UNITED STATES PATENT AND TRADEMARK OFFICE

APPLICATION NO.	FILING DATE	FIRST NAMED INVENTOR	ATTORNEY DOCKET NO.	CONFIRMATION NO.
10/529,154	03/24/2005	Yoshihisa Umeno	10873.1582USWO	1870
52835	7590	10/16/2007	EXAMINER	
HAMRE, SCHUMANN, MUELLER & LARSON, P.C.			CORRIGAN, JOSEPH JAMES	
P.O. BOX 2902			ART UNIT	PAPER NUMBER
MINNEAPOLIS, MN 55402-0902			3744	
			MAIL DATE	DELIVERY MODE
			10/16/2007	PAPER

DETAILED ACTION

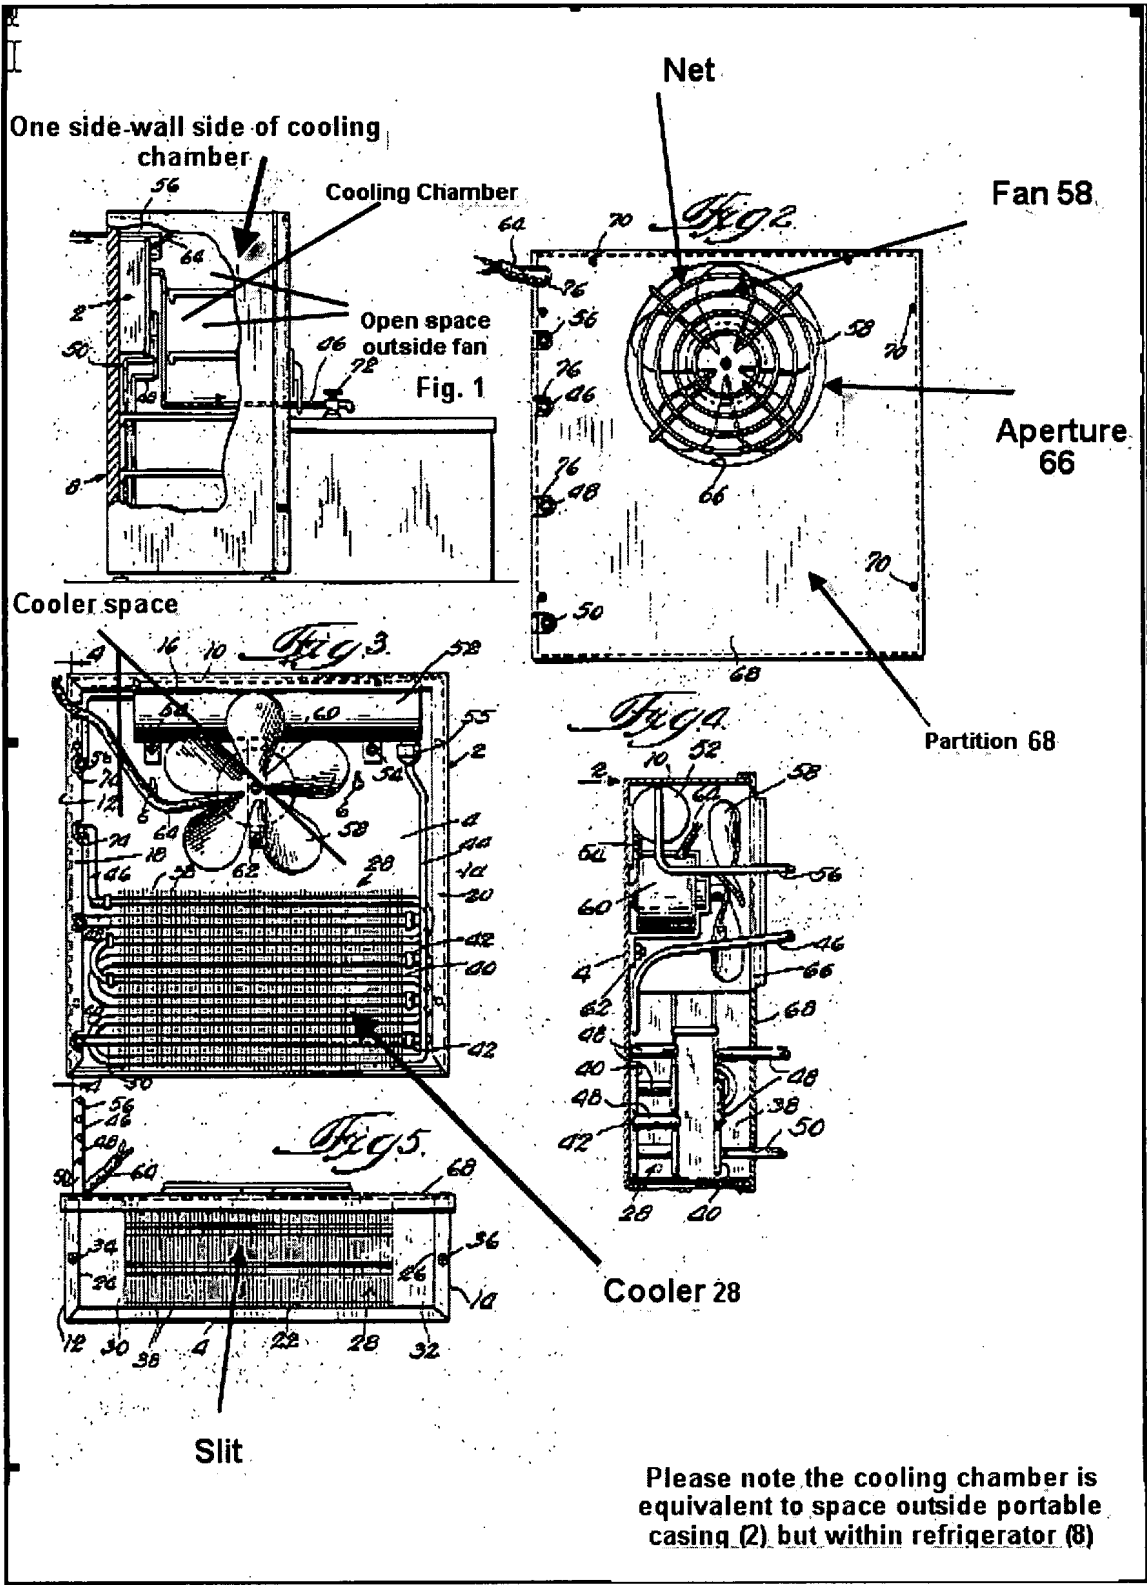
- A cooler (28) provided on at least one side-wall side (8A) of a chamber (see marked-up figure 1) formed with a thermally insulated box.
- A cooling chamber (see marked-up figure 1) in front of the cooler (28).

- A fan (58) that allows air in the cooling chamber (see marked-up figure 1) to flow.
(see figure 4)
- Wherein the cooler (28) and the cooling chamber (see marked-up fire 1) are partitioned by a partition (68) so as to allow cold air to be accumulated in the cooler (28).

- The fan (58) is disposed on a side of a cooler (28) relative to the partition (68).
(see figure 4)
- The partition (68) in front of the fan (58) has an aperture (66) formed in the flat sheet portion. (see figures 1 & 4)

- An open space (see marked-up figure 1) is formed between the fan (58) and the flat sheet portion (partition and bottom portion of cooler casing) in which the aperture (66) is formed (see figs. 2 and 4).

- Cold air accumulated in a space inside the partition (68) and hot air in the cooling chamber (see marked-up figure 1) are exchanged by the fan (58) through the aperture (66). Since applicant does not specifically define in claim language airflow in terms of an implied or explicit restriction to contribution from the evaporator section, an "elevator" type circular flow meets the claim limitation. In other words, since "hot air" originating in cooling chamber gets drawn up through the bottom opening (slot) in cooler casing and out through the aperture, ultimately blending the hot and cold air. Broadly speaking one can surmise by using the applicants phrasing "exchanging by the fan through the aperture" being the most dynamic segment of the mixing cycle.

In re to claim 2, J. H. Lazar discloses in fig. 2 that dimensions of the aperture (66) are larger than a diameter of the fan (58).

In re to claim 3, J. H. Lazar discloses in fig. 4 that when viewing the fan (58) in a direction of a rotation shaft of the fan (58), the fan (58) is disposed in the aperture (66) and there is an open space (see marked up figure 1) outside the fan (58).

In re to claim 6, J. H. Lazar discloses in fig. 3, the fan (58) is disposed above the cooler (28).

In re claim 8, J. H. Lazar discloses that a slit is formed in the partition (68) at a portion opposed to the cooler (28) or a portion below the cooler (28). Broadly recited, a "slit" (see marked-up drawing 5) is an opening, and thus, Lazar teaches a slit.

In re to claim 10, J. H. Lazar discloses that a safety cover (see marked-up drawing 2) is disposed over the aperture (66) using a net (see marked up figure 2).

Scofield Patent # 2,957,067

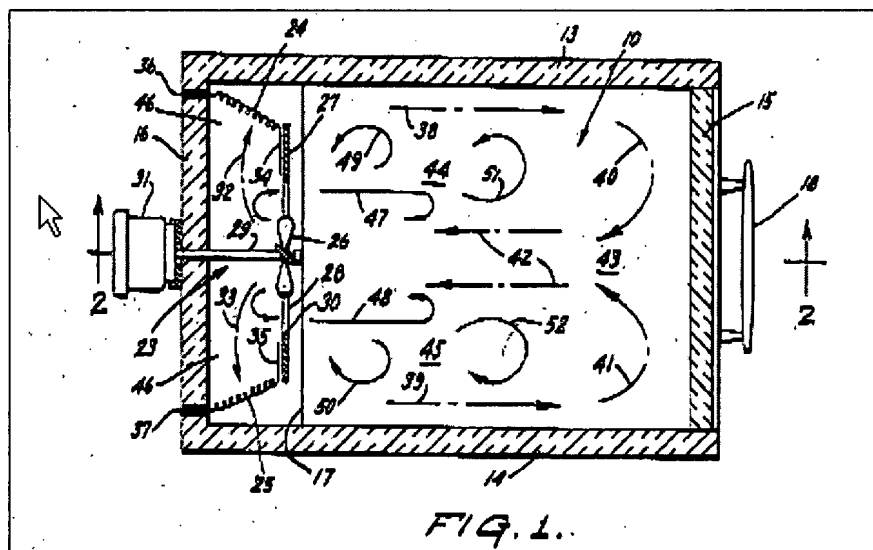
Scofield teaches (fig.1 above) and in column 4, lines 13-27 "[using an oversized fan aperture 28] "..... In normal operation the air of said streams is reasonably hot [cold], although such air may be slightly cooler [warmer] than the air of forward currents 38,39, the thermal gradient being due to inherent and unavoidable radiation of heat (cold) from the extended surfaces of flat oven (10) [refrigerator]. It will thus be seen that returning or short-circuiting airflows (47,48) contribute substantially to the desired affect of additional heating [cooling] to areas 44,45 into which they circulate.

In addition, the introduction of such return currents 47, 48 causes added heating [cooling] of said areas 44, 45 and consequently, satisfactory heat (cold) equalization between all oven [refrigerated] areas, by the inherent creation of eddies 49, 50, 51, 52

along the boundaries of counter current air flows 47, 38 and 48, 39. Such eddies deflect heated [cooled] air, of maximum [minimum] temperature, from the currents 38, 39 which flow alongside walls 13, 14, and the deflected hot [cold] air is then diffused by such eddies in areas 44, 45. Thus the jet-like and compact form of said hot [cold] air currents 38, 39 is largely destroyed and there is created, in effect, the equivalence of an air guiding and distributing structure, in the area receiving heated [cooled] air, equivalence being provided by the mere employment of oversize fan aperture 28, in the area wherefrom air is supplied by the heaters [cooler]."

It would have been obvious to one of ordinary skill in the art at the time of the invention was made to modify Lazar with teaching of "oversized fan aperture" structure to generate airflow dynamics in cooling chamber. ***This airflow signature in its purest form approaches an ideal three-dimensional heat gradient for cooking or cooling {value(ideal) = zero}, not unlike how multi colored ingredients in a blender become one. Temperature gradient turbulence dynamics, irrespective of its place in the heat spectrum correlates one to one up and down the heat scale, thereby satisfying airflow requirement presented by applicant.*** It would be advantageous to create eddy currents in that it stalls to to the extent that the colder air is distributed more uniformly keeping all products be cooled at the same low temperature.

In re claim 5, D. W. Scofield (see fig. 1) teaches that using an oversized fan aperture one can create eddy currents, to in effect, "... deflect heated air ... ", as stated in column 4, line 18, which is analogous to suppressing flow speed of cool air in a cooling system.
